POST CONSTRUCTION SAFETY AUDITS: SEAL EXTENSIONS  
FINAL REPORT

**PHOTO 10 - GUARD RAILING**

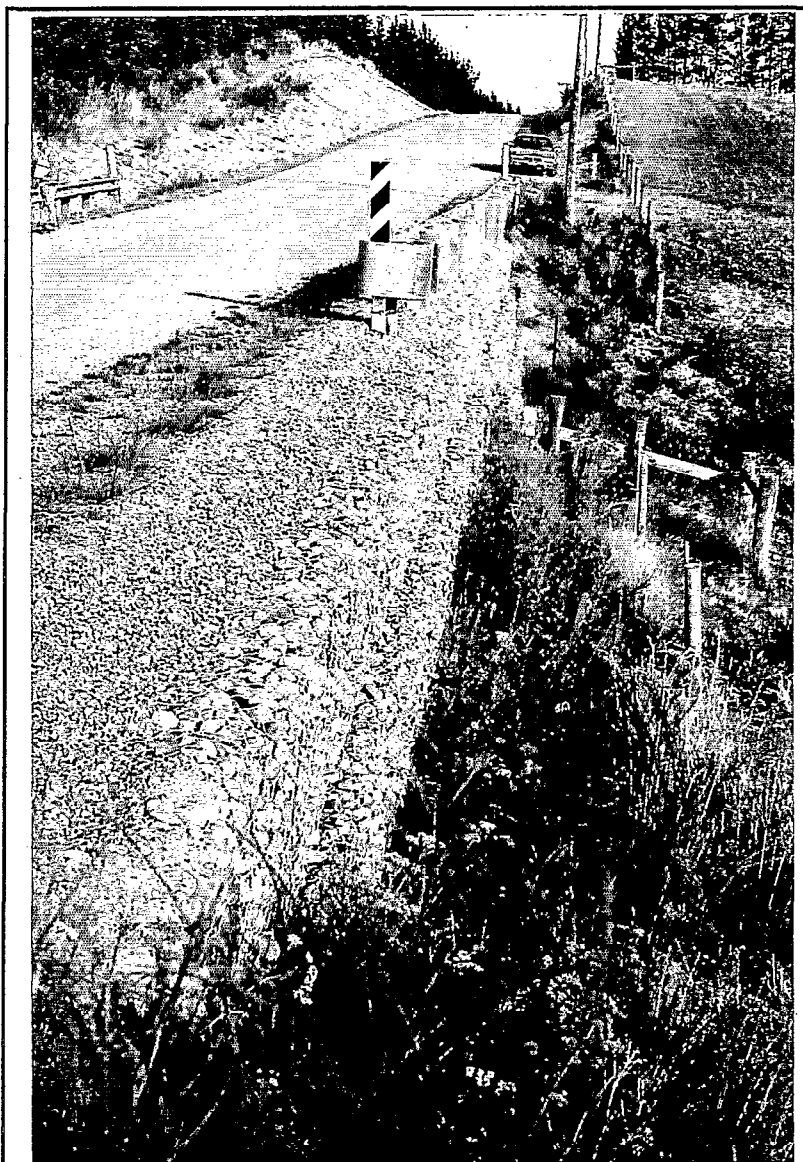
Several unsafe and poor examples of guard rail were identified. In a number cases it was considered the guard rails could not possibly achieve the intended purpose due to the manner in which they were installed. They were little more than an expensive sight rail.

- Posts installed on top of gabion walls within the top gabion basket.
- Situations where the finished level of the tops of gabion walls were up to 400-500mm below seal level. Timber planks had been placed on top of the gabion walls against the guard rail posts to retain the metal shoulder. This effectively increased the length of the post and the 'lever arm' from the standard 550mm to 950-1050mm above seal level significantly reducing the lateral resistance.

Note the guard rail posts are embedded in a gabion wall. The guardrail lacks sound anchorage and lateral restraint, has no flares and ends well short of the extent of the retaining wall.

*That Transfund require Road Controlling Authorities to undertake safety inspections of all guardrails to ensure that they are correctly installed.*

*That Transfund encourage Road Controlling Authorities/Consultants to provide additional training on the design and installation of guard railing.*

PHOTO 13 - SIDE DRAINS  
Note depth of adjacent side drain

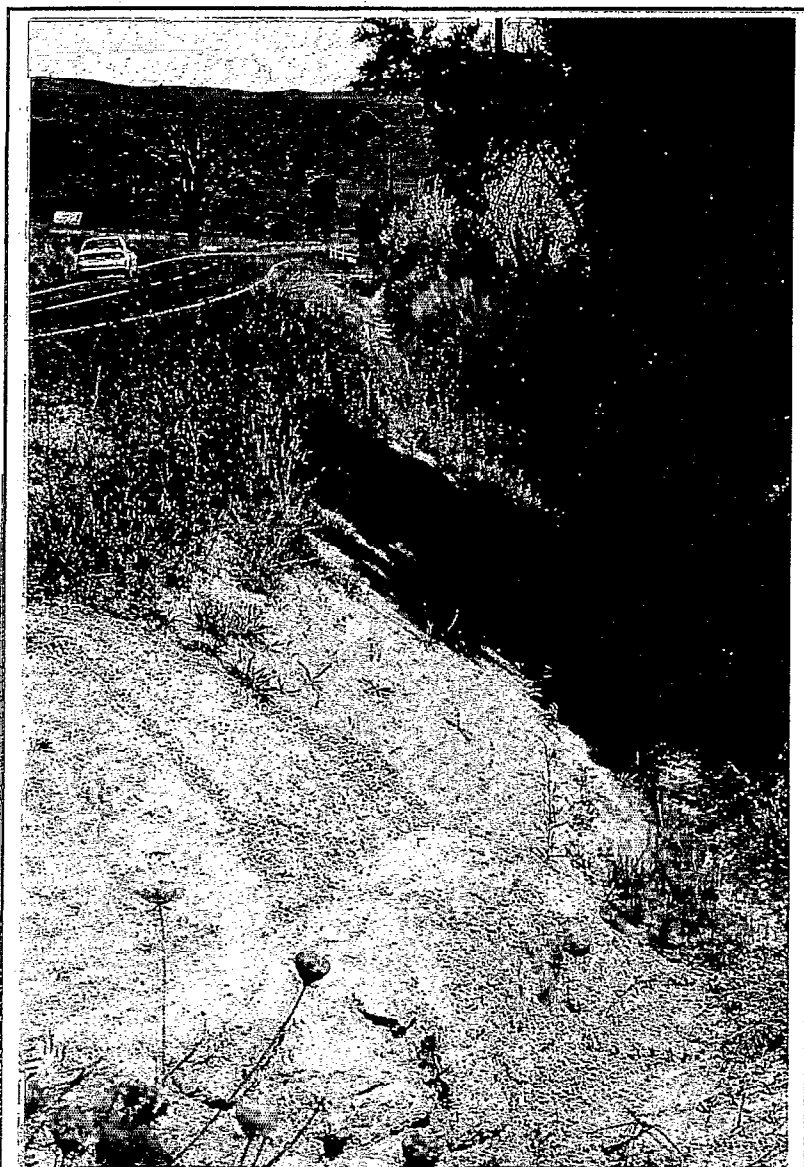
A number of projects had side drains which appeared unnecessarily deep. This may have been as a result of the overlay/shape correction incorporated in the seal extensions. Many were on steep slopes and erosion/undermining of the edge support was occurring. One project had excessively deep side drains adjacent to the road. This was apparently related to difficulties in finding an outlet and problems with the landowner.

*Transfund should require Road Controlling Authorities to ensure that in general the depth of side drains not greater than that necessary to provide adequate drainage. Deep outlet drains should not be located adjacent to the highway.*
